UNITED STATES PATENT AND TRADEMARK OFFICE

APPLICATION NO.	FILING DATE	FIRST NAMED INVENTOR	ATTORNEY DOCKET NO.	CONFIRMATION NO.
09/614,155	07/11/2000	Dan A. Steinberg	ACT-121	1603

Office Action Summary

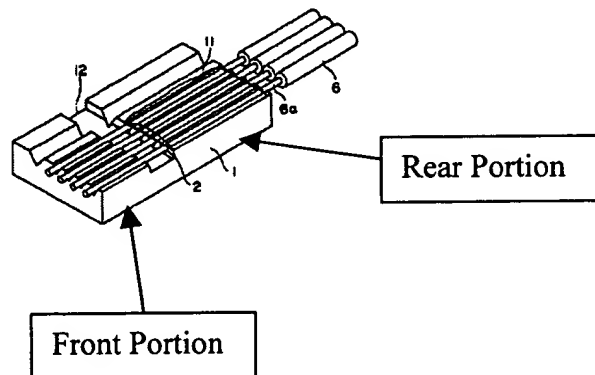
13. Claims 1, 3, 23, and 24 are rejected under 35 U.S.C. 102(b) as being anticipated by Yamashita et al (JP410227948A).

Yamashita discloses an optical fiber array apparatus comprising a V-groove chip 1 and an optical fiber 6. The V-groove chip 1 has a V-groove 2, a rear portion, a front portion, a front face and a wick stop trench 12. The optical fiber 6 is disposed in the V-groove 2. The optical fiber 6 is not bonded to the front portion of the chip 1, but the optical fiber 6 is bonded (at point B) to the rear portion of the chip 1. The optical fiber is extending from the rear portion. The wick stop trench 12 is in between the rear portion and the front portion.

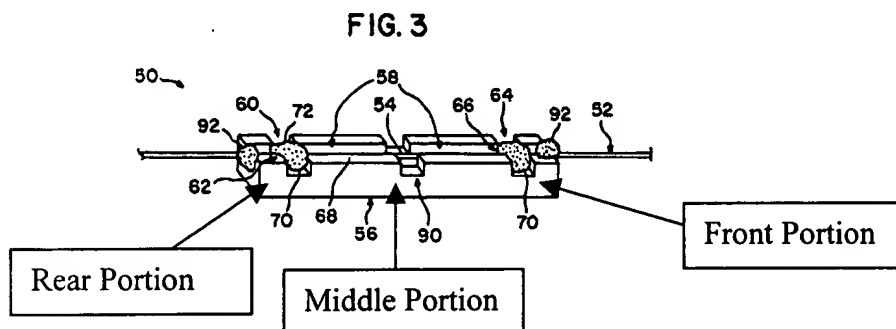
Claim 12 recites that the V-groove in the front portion has a flat bottom surface, but Yamashita does not disclose a flat bottom surface for the V-groove in the front portion.

Yamane discloses an optical fiber apparatus having V-groove 24, 26 or V-groove with a flat bottom surface 14, 16. Murphy also discloses an optical fiber apparatus having V-groove with a flat bottom surface (see Figs. 2-5).

It would have been obvious at the time the invention was made to a person having ordinary skill in the art to provide a V-groove with a flat bottom surface because this would provide a stronger substrate compared to a substrate with a V-groove.
